1984 Corvette: Recall: Front Brake Caliper Bracket Bolt

Subject: PRODUCT SAFETY FRONT BRAKE CALIPER BRACKET BOLT

Model and Year: 1984 CHEVROLET CORVETTE MODELS (VIN: E5100001 - E5109828)

Bulletin Number: 84-C-02 - (06/01/1983)

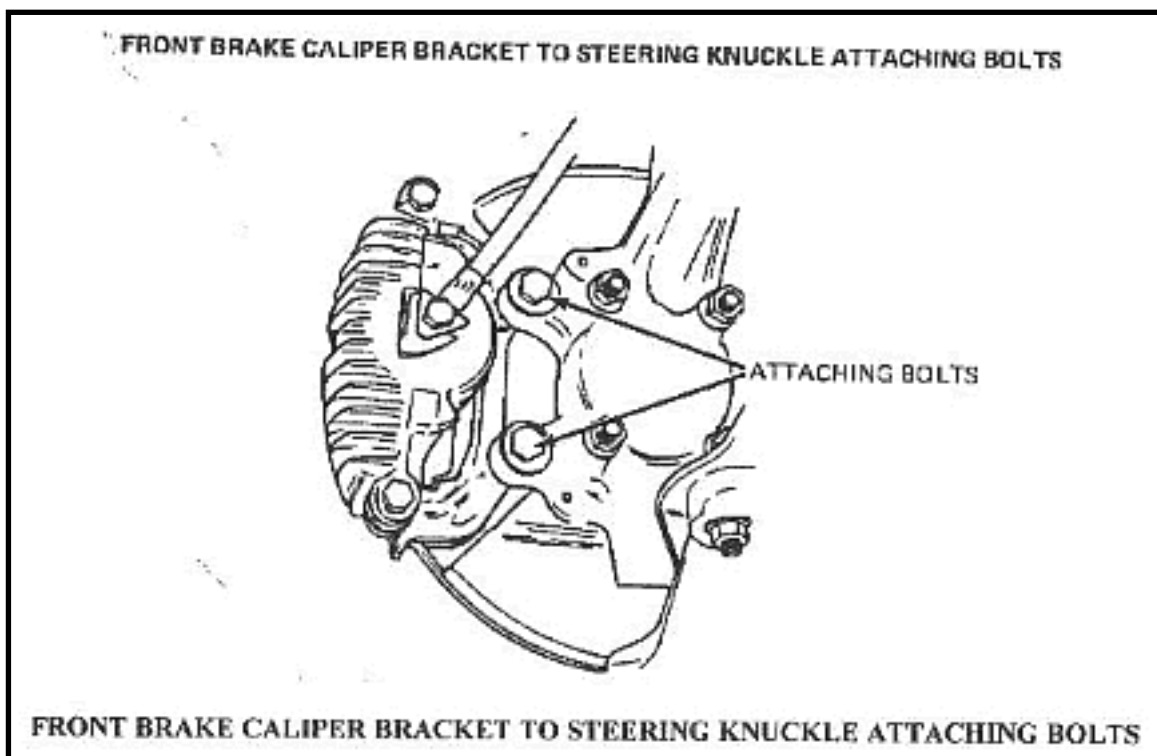
GENERAL MOTORS HAS DETERMINED THAT A DEFECT WHICH RELATES TO MOTOR VEHICLE SAFETY EXISTS IN CERTAIN EARLY PRODUCTION 1984 CORVETTES. THE FRONT BRAKE CALIPER BRACKET TO STEERING KNUCKLE ATTACHING BOLTS MAY LOOSEN AND FALL OUT. THE FRONT BRAKE CALIPER MAY THEN BECOME PARTIALLY DETACHED FROM THE KNUCKLE ASSEMBLY AND MAY CAUSE THE WHEEL TO LOCK. SHOULD THIS OCCUR WHILE THE VEHICLE IS IN MOTION, IT COULD RESULT IN A LOSS OF CONTROL, A VEHICLE CRASH COULD OCCUR WITHOUT PRIOR WARNING.

TO PREVENT THE POSSIBILITY OF THIS CONDITION OCCURRING, CHEVROLET DEALERS ARE TO REPLACE THE FRONT BRAKE CALIPER BRACKET TO STEERING KNUCKLE ATTACHING BOLTS ON ALL INVOLVED VEHICLES IN ACCORDANCE WITH THE SERVICE PROCEDURE AS OUTLINED IN THIS CAMPAIGN BULLETIN.

140799998 4 FRONT BRAKE CALIPER BRACKET TO STEERING KNUCKLE ATTACHING BOLT

IMPORTANT: THE NEW BOLT P/N 140799998 CAN BE IDENTIFIED BY THE ORANGE COLORED ADHESIVE PATCH MATERIAL ON THE BOLT THREADS.

1. RAISE HOOD.
2. REMOVE THE UPPER CALIPER ATTACHING BOLT.
3. USING THE NEW 3/8 IN. CYLINDRICAL WIRE BRUSH PROVIDED, FIRST THOROUGHLY CLEAN THE BRUSH WITH 1,1,1 TRICHLORETHANE SOLVENT; LET DRY.
4. CLEAN THREADS IN THE UPPER CALIPER ATTACHMENT BY THREADING THE BRUSH THROUGH THE THREADS AS FAR AS POSSIBLE, THEN REMOVE BY REVERSE THREADING. THIS STEP MUST BE PERFORMED TO REMOVE RESIDUAL TEFLON NO MATTER HOW CLEAN THE THREADS APPEAR.
5. BLOW OUT THREADS WITH AIR GUN.
6. INSTALL NEW BOLT PROVIDED, P/N 140799998, AND TORQUE TO 97 N.M (70 FTL.LB.).
7. REPEAT THE PROCESS FOR THE LOWER CALIPER ATTACHING BOLT.

8. RECHECK TORQUE ON BOTH BOLTS IMMEDIATELY.
